MAULE AEROSPACE TECHNOLOGY, INC.

SERVICE BULLETIN #16

SUBJECT: Carburetor Heat Air Valve.

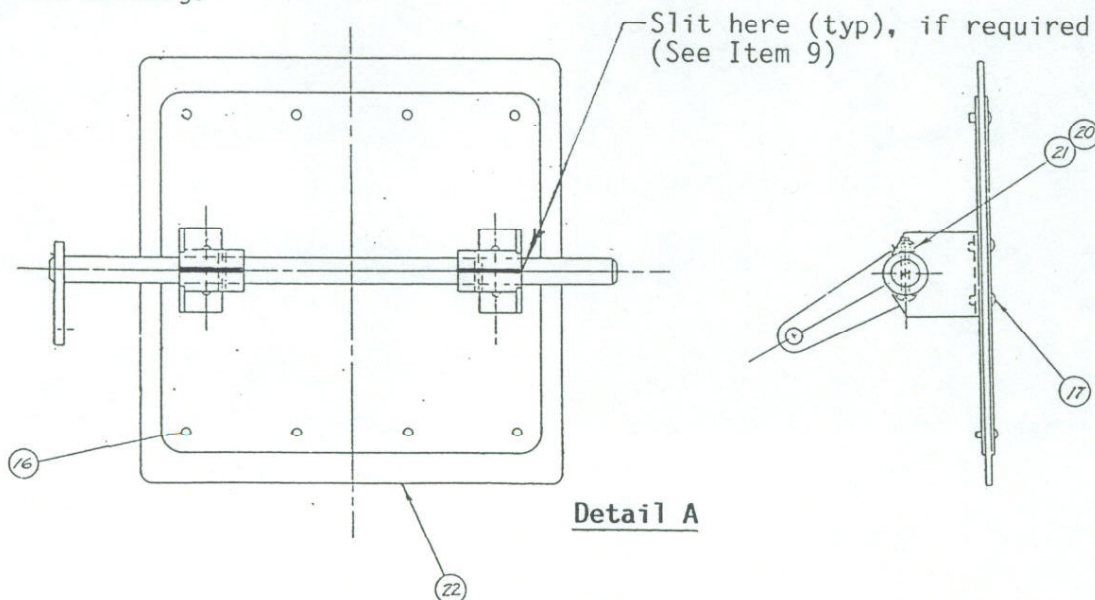
STATUS: Service Letter No. 56, attached for reference, is a mandatory requirement for inspection of carburetor heat air box valve seal. This Bulletin provides a more durable material for seal replacement, requires inspection and possible replacement of attachment hardware and provides a repair for a loosened valve plate. (Current seals from the factory are made from a black nitrile rubber with cotton insert which is considerably tougher than the red silicone rubber and also the previously used black rubber without the reinforcing insert.) (Screw replacement provides for an unthreaded portion through shaft.)

- 3) Remove the air box from the carburetor.
- 4) Remove the valve plate from the air box. This is accomplished by removing two AN526-8 screws and Nuts (Items 20 and 21, Detail A) which retain the valve plate to the shaft. Withdraw the shaft from the air box, then remove the valve plate.

- 6) Remove the existing rubber seal and install a new part no. 5286X-22 Buna-N rubber seal (with cotton insert).
- 7) Reassemble the valve plate assembly using AD3-4 rivets and the brackets to valve plate assembly using AD3-5 rivets.

- 9) Reinstall the valve in the air box and secure with the two (2) new MS27039-0814 screws and AN365-832 self-locking nuts. **CAUTION: Replacement of the screws and nuts regardless whether seal is changed or not is strongly recommended. If screw holes are elongated, repair as follows:**

- a. Slit top side of shaft brackets as shown in Detail "A" using a hacksaw blade (approximately 1/32" wide). Proceed with reinstalling valve and tighten securely. This will allow bracket to clamp shaft and prevent further wear.

- 8) Trim the seal to fit the air box. The sides of the seal should clear the side walls of the air box by 1/32 inch maximum. The upper and lower ends of the seal should extend out from the metal plates by approximately 3/4 inch and lie against the upper and lower walls of the air box with valve in its extreme positions.
